**Proposed Revisions to a Standard Plans Index**

Index Number: 521-010

Index Title: Opaque Visual Barrier

OPAQUE VISUAL BARRIER	INDEX 521-010	SHEET 1 of 2
-----------------------	------------------	-----------------

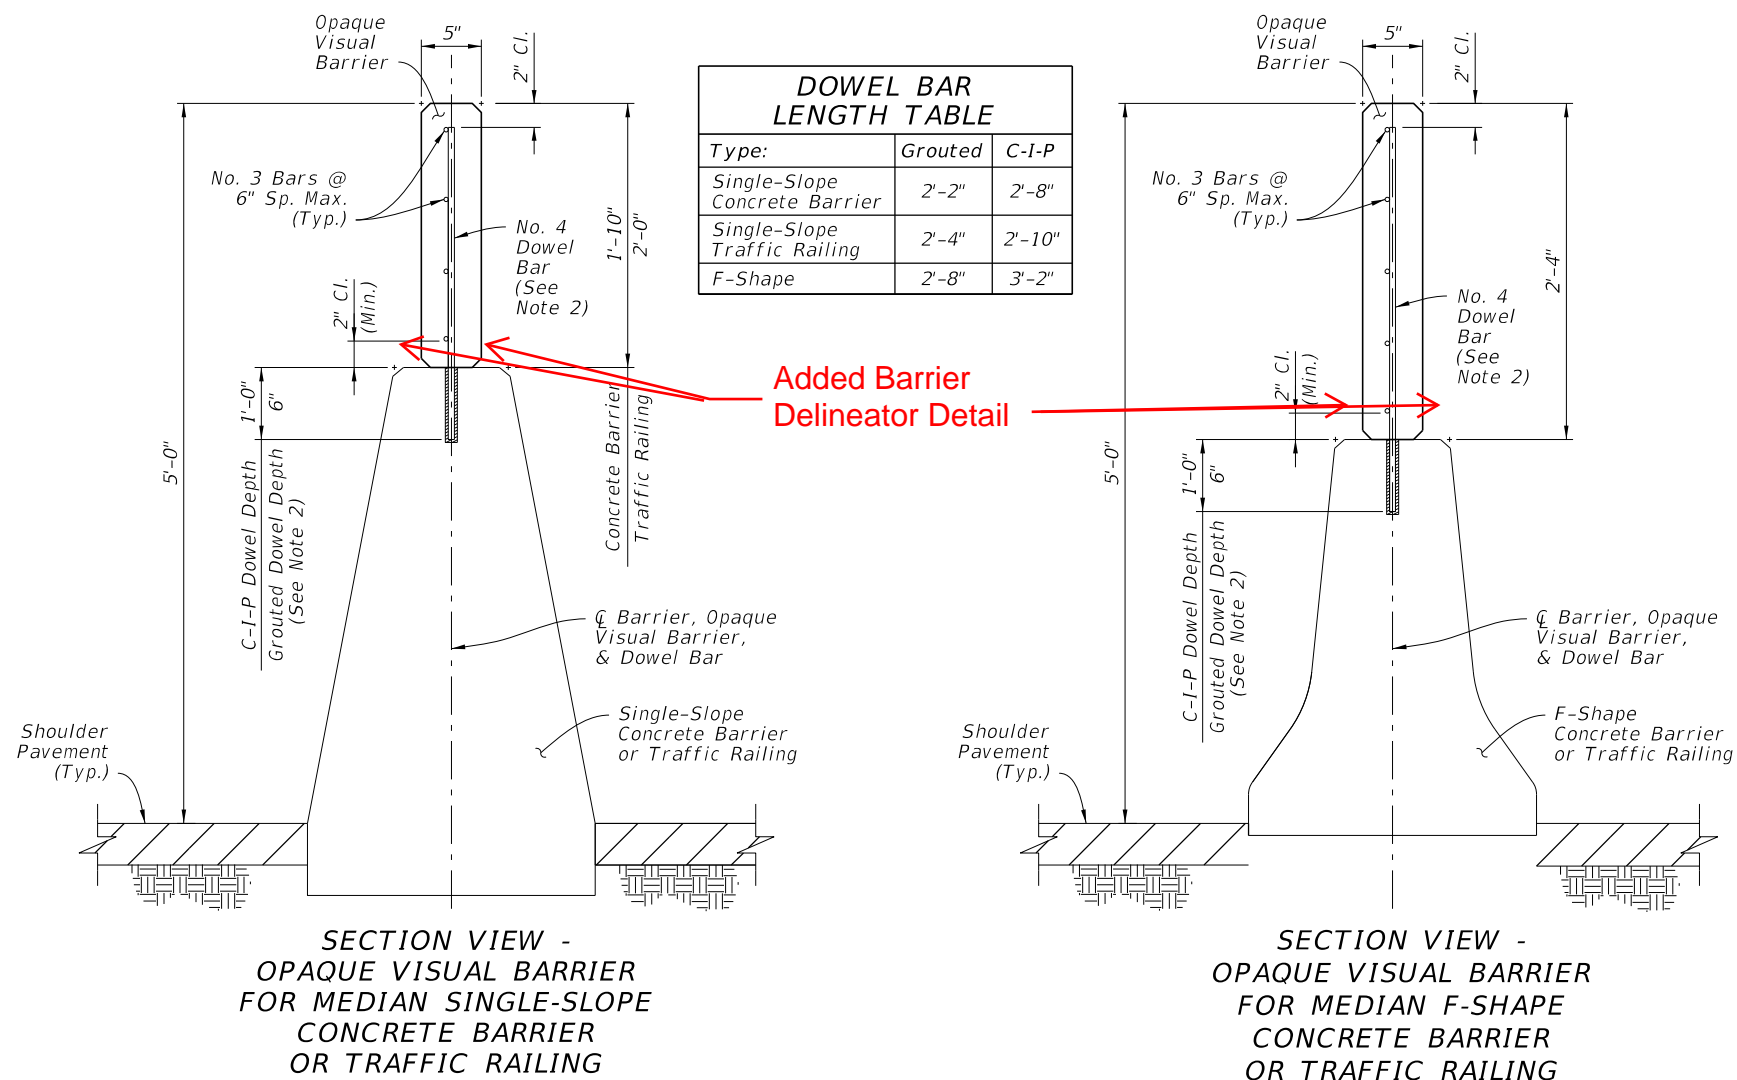
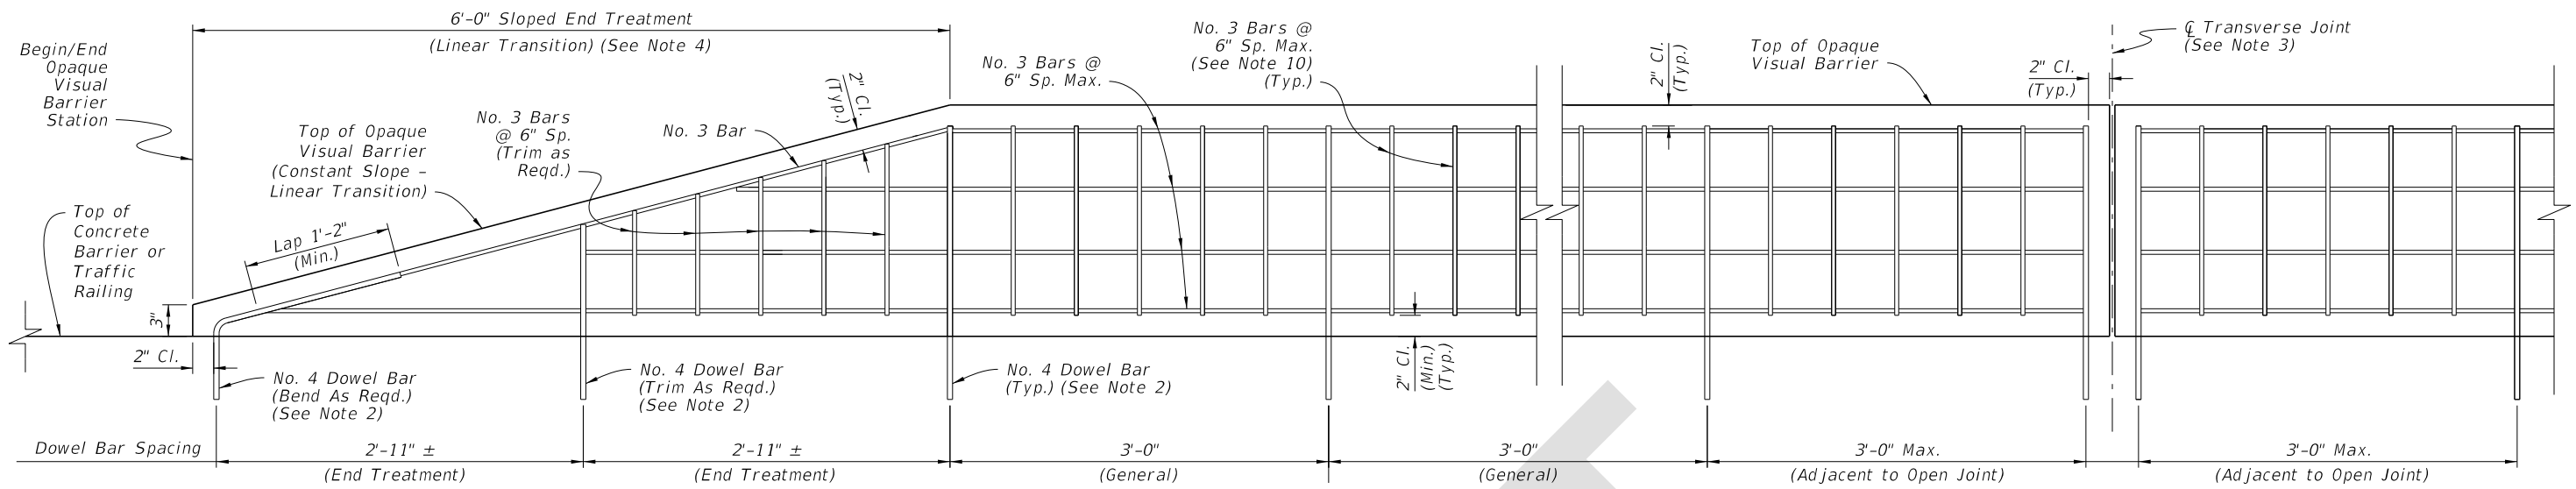
Sheet 1: Section Views - Added barrier delineator placement details and callout; Note 9: Added explanation for how to locate barrier delineators with split barrier sections.

Added detail to clarify placement location of barrier delineators when an Opaque Visual Barrier blocks the standard placement location on top of the barrier.

Added Barrier Delineator placement instruction

Added Barrier Delineator Detail

9. SPLIT CONCRETE BARRIER SECTIONS: For split Concrete Barrier sections that run separately (for vertical structures, bridges, etc.), OVB is only required on top of one of the Concrete Barrier sections. Place OVB on top of the Concrete Barrier section with the highest elevation. For these segments, mount barrier delineators on only the OVB face nearest the roadway (barrier mount other side). Longitudinally overlapping OVB runs are permitted where called for in the Plans, as designated with overlapping Begin and End Station OVB callouts.
